Access Compliance Report Public Rights-of-Way (RR Crossings)

Intersection ID: 10032938	Main Street: NEW_BERN_ST	Location: N/A
ADA ID: 97F681274301	Overall Compliance: No	Severity Score: 0.0
Codes/Mitigation Info/Possible Solution		Field Measurements/Component Compliance

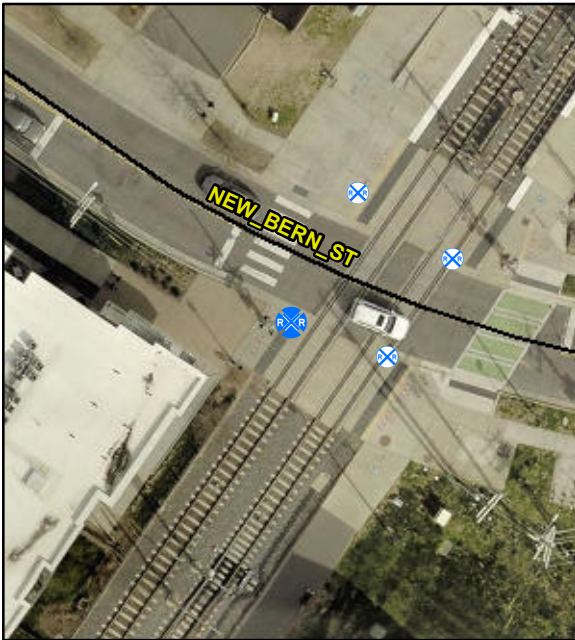
**Remove & Replace Detectable
Warning System. Provide Pedestrian
Gate. Remove & Replace Walking
Surface Adjacent to Rail.**

R302.7.4, R305.2.5

Compliance	Description	Data
Yes	DWS Provided?	Yes
Yes	DWS Contrast?	Yes
Yes	DWS Width (in)	Yes
Yes	DWS Length (in)	36.0
No	DWS Offset (in)	30.0
No	Pedestrian Gate?	No
N/A	DWS Outside Gate?	No
N/A	Rail Type?	LightRail
No	Flangeway Gap (in)	3.0
Yes	Sidewalk Width (in)	147.0
